# UNITED STATES PATENT AND TRADEMARK OFFICE

APPLICATION NO.	FILING DATE	FIRST NAMED INVENTOR	ATTORNEY DOCKET NO.	CONFIRMATION NO.
10/034,208	12/28/2001	Timothy A. Limon	ACS 59115	7764
24201	7590	12/13/2004	EXAMINER	
FULWIDER PATTON LEE & UTECHT, LLP HOWARD HUGHES CENTER 6060 CENTER DRIVE TENTH FLOOR LOS ANGELES, CA 90045			HO, UYEN T	
			ART UNIT	PAPER NUMBER
			3731	
DATE MAILED: 12/13/2004

## Office Action Summary

Sheet 4 of 9

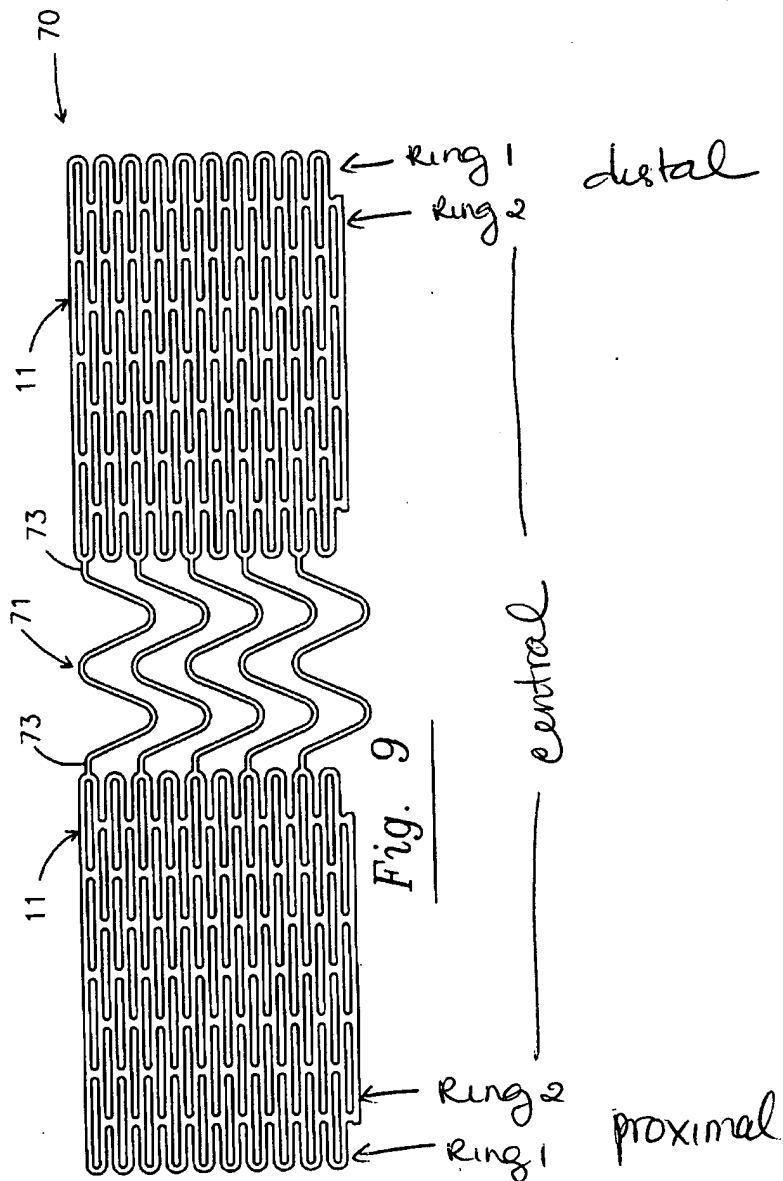
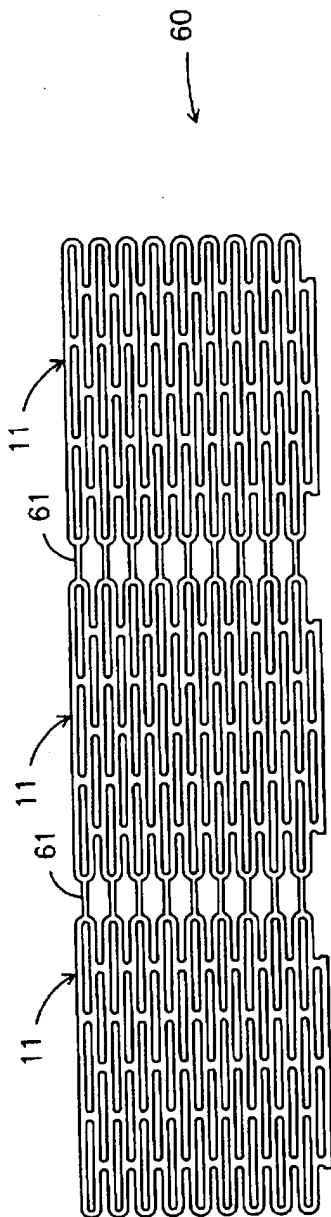
3. Claims 1-38, 49-51, 53-66 are rejected under 35 U.S.C. 102(b) as being anticipated by Jayaraman (5,755,781). Jayaraman disclose a stent including first, second and third sections having pattern and structure configurations as claimed (figures 8-9). Note: The introductory statement of intended use and all other functional statements have been carefully considered but are deemed not to impose any structural limitations on the claims distinguishable over the Jayaraman's stent which is capable of being used as claimed if one desires to do so.

Wherein the distal section and the proximal section having cylindrical rings having a first longitudinal length and the central section having a cylindrical ring ( 71) having a second longitudinal length that is longer than the first longitudinal length (See illustration of figure 9 of Jayaraman reference attached)
